NGDV – Technical Bulletin

Title: Oshkosh Diagnostic Tool (OKDT) Release
11/13/2025

Number: NGDVTB006

Revision: A

ECU Reprogramming/Replacement

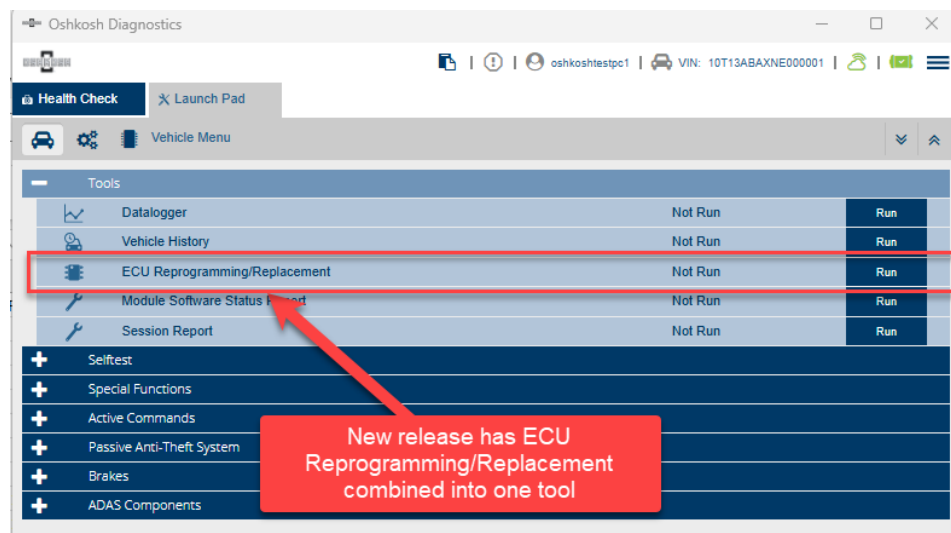
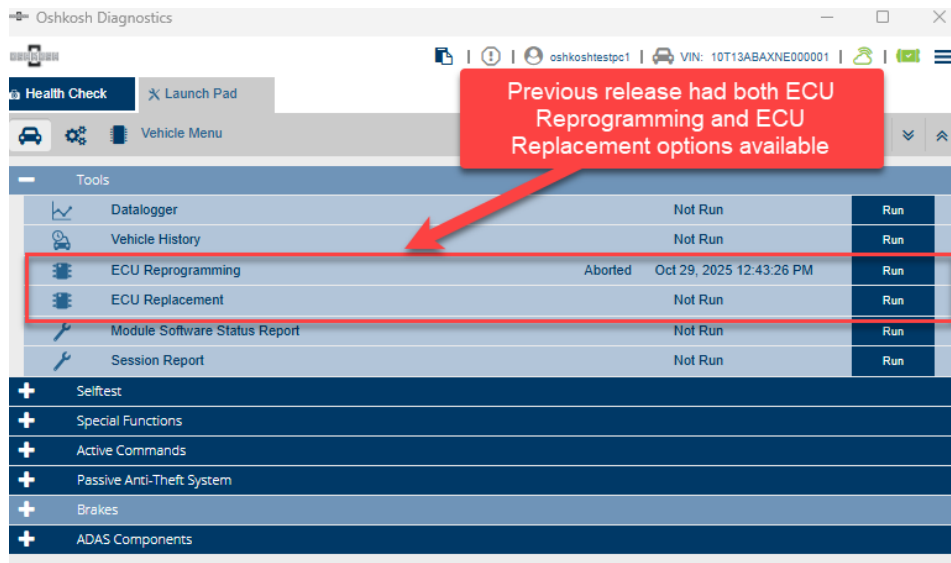
Previously ECU Replacement and ECU Reprogramming were separate menu items under the Tools menu. With this release, these menu items have been consolidated into one tool to eliminate confusion when to run one tool or the other.

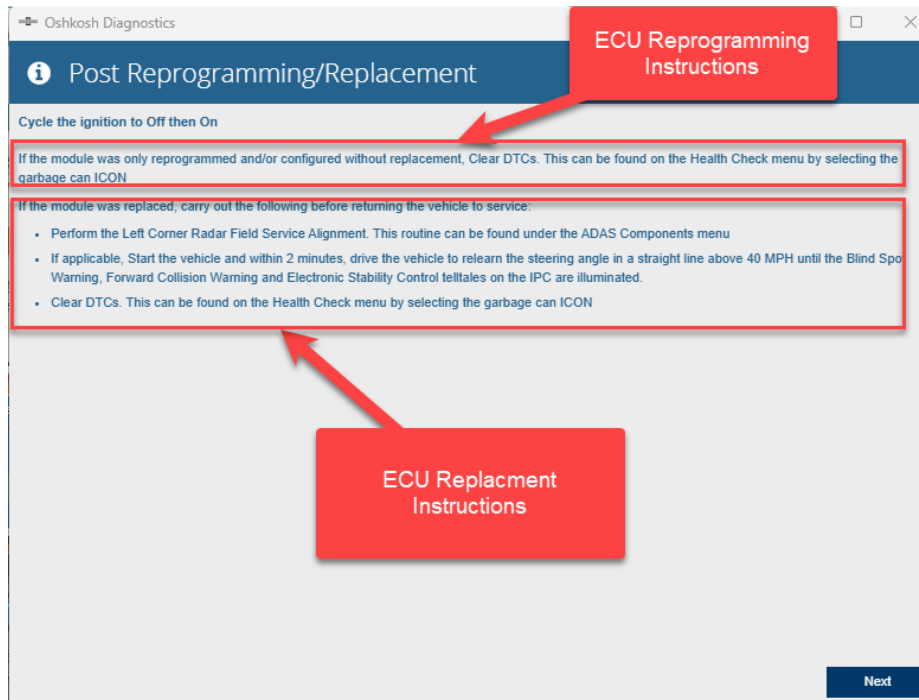
In addition to the combination of ECU Reprogramming/Replacement into one tool, post reprogramming/replacement screens have been modified to identify what additional steps should be taken depending on which action is taken - ECU reprogramming only or ECU replacement.

Addition of Session Report

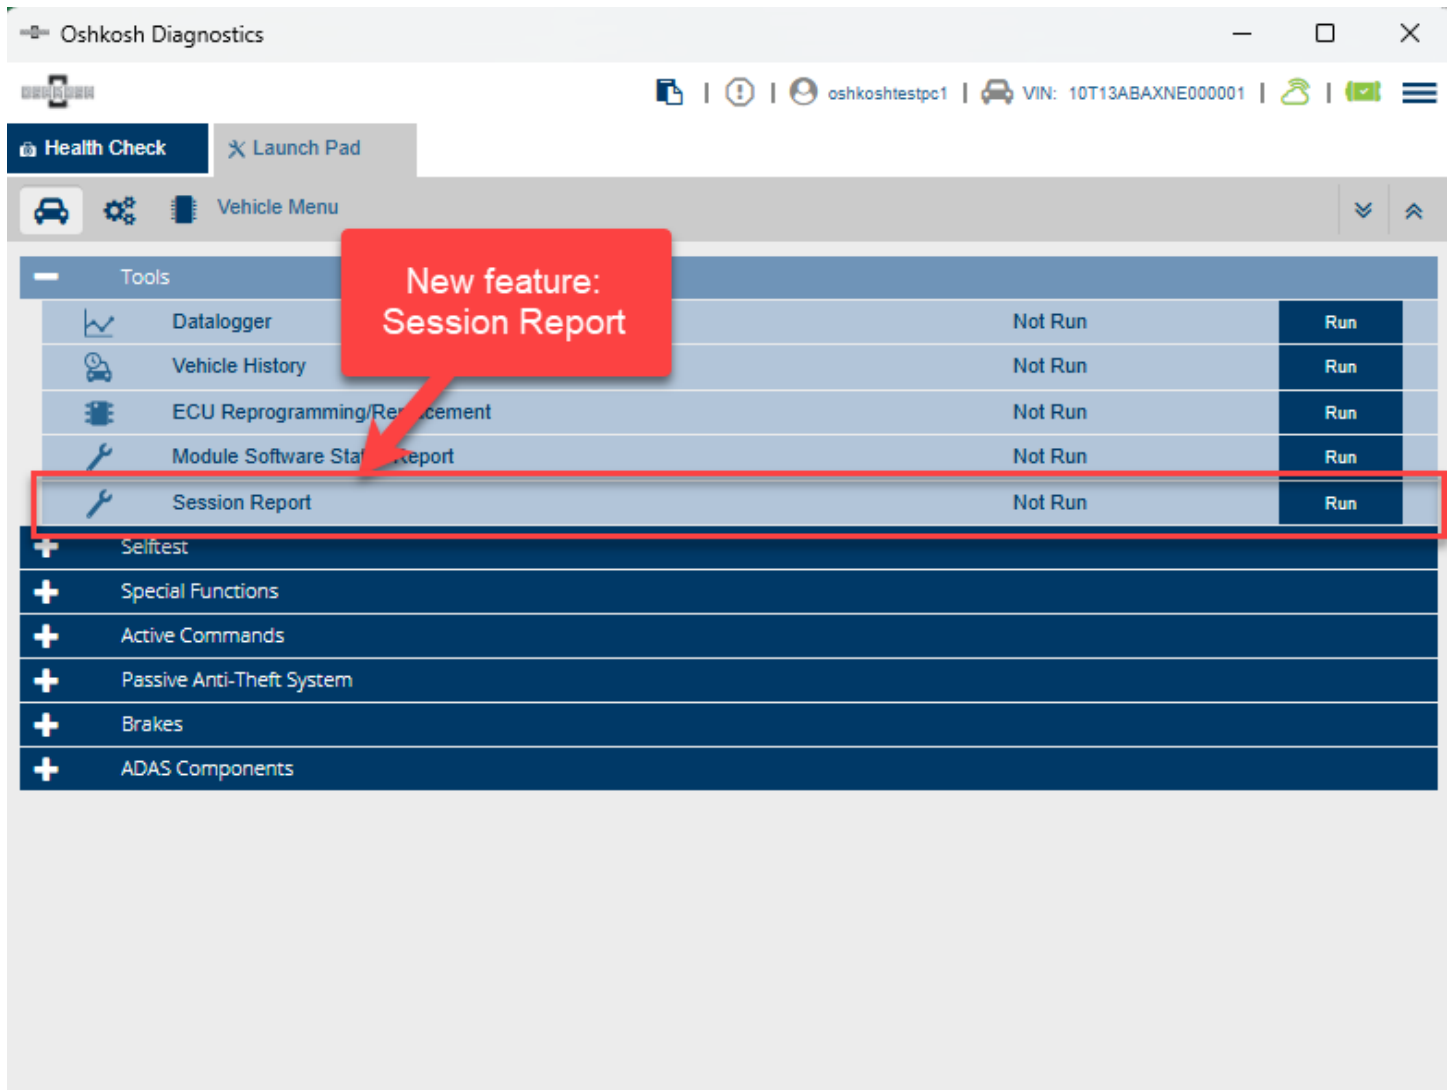
A session report has been added to the Tools section. This feature will allow a technician to review/save/print the session information from the current vehicle session for use with warranty claims, vehicle history, or remote diagnostic sessions. This report will retain all vehicle diagnostic state information along with steps taken by a technician while using the tool.

1. Click the Session Report option under “Tools” in the Quick Start Menu.

Addition of the D-PDU interface to OKDT Installation

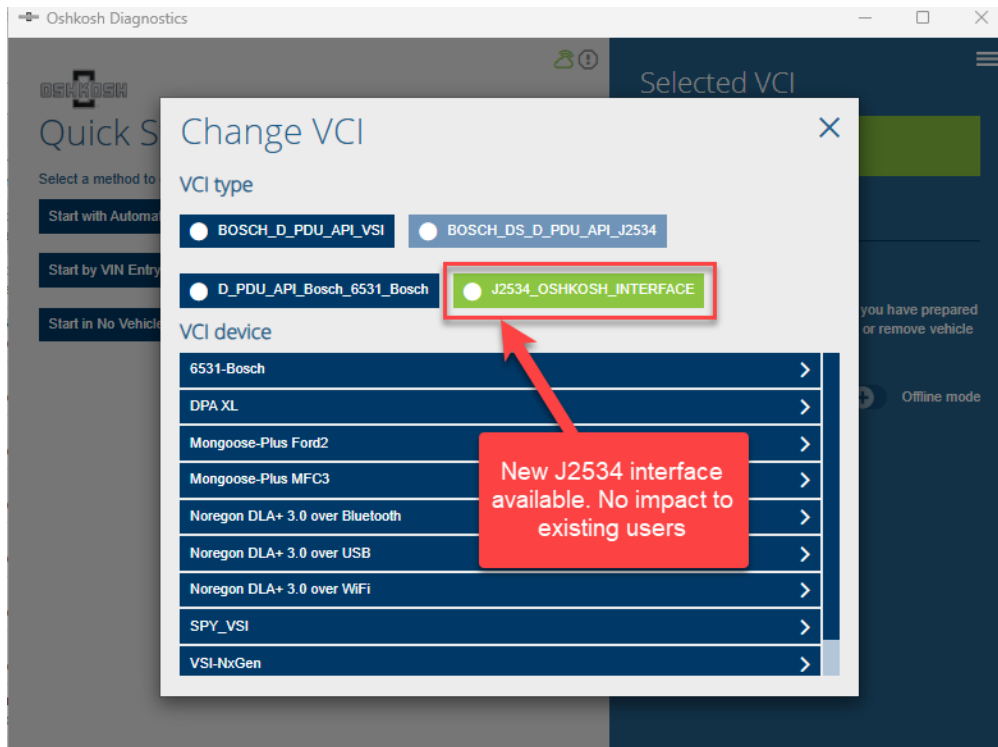
- There is a new version of the J2534 D-PDU interface included with the release of this new software.
- This will be visible if the user selects the Change VCI on the Quick Start page.
- This selection option will have no impact to existing users as the current Bosch_DS_D_PDU_API_J2534 interface still functions.
- New users will only see the J2534_OSHKOSH_INTERFACE and will no longer need to download the separate interface.
